UN Regulation No. 129 (Enhanced Child Restraint Systems)**Proposal for Supplement 3 to the 02 series of amendments to
UN Regulation No. 129 (Enhanced Child Restraint Systems)****Submitted by the expert from France***

The text reproduced below was prepared by the expert from France on behalf of the Technical Services Group (TSG) on UN Regulation No. 129 to clarify the test protocol for the opening force of the ISOFIX attachments. The modifications to the current text of UN Regulation No. 129 are marked in bold for new or strikethrough for deleted characters.

"Figure 3

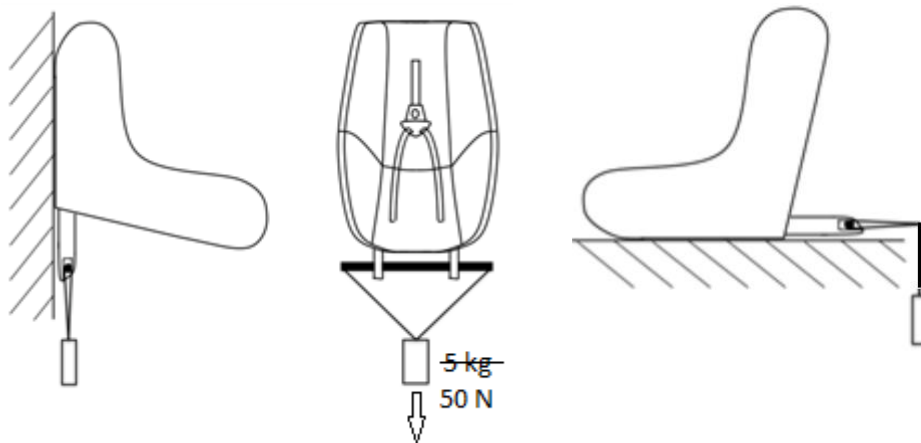
"7.2.8. The complete seat, or the component fitted with ISOFIX attachments (e.g. ISOFIX base) if it has a release button, is attached rigidly to a test rig in such a way that ISOFIX connectors ~~are vertically~~ aligned as shown in Figure 3. A 6 mm diameter bar, 350 mm long, shall be attached to the ISOFIX connectors. A ~~mass force of 5 kg~~ **50 ± 1 N shall be applied to the** ~~shall be attached to the~~ extremities of the bar."

Figure 3, amend to read:

Either option is permitted as long as a force of 50 N is applied.
